**Subject:** 3024 69th Ave SE

My name is Clayton Herbst and I'm an architect working on a new single family house @ 3024 69th Ave SE (TPN: 217510315). I had called earlier about coming in to discuss some code/development questions about the site. As far as state of affairs, we are currently in the prelim design phase and want to understand the site parameters with more granularity before presenting any options to our client.

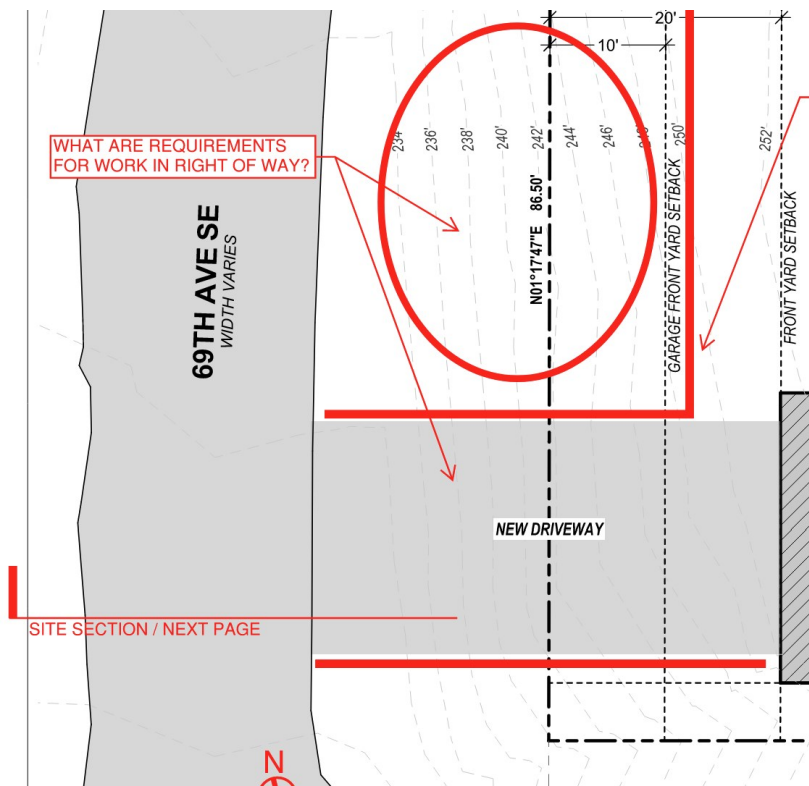
In the meantime, we are hoping we can get a targeted response from you all specifically regarding >the downslope height limit and whether a step back in the building massing alleviates this requirement

MICC defines façade as any exterior wall of a structure, including projections from and attachments to the wall. Projections and attachments include balconies, decks, porches, chimneys, unenclosed corridors and similar projections. In the diagram below, the façade on the downhill side of the structure would include the garage and levels 1 and 2. Therefore, the shown downhill façade height would be 34.06 feet and would not comply with the height limit listed in MICC 19.02.020(E)(2).
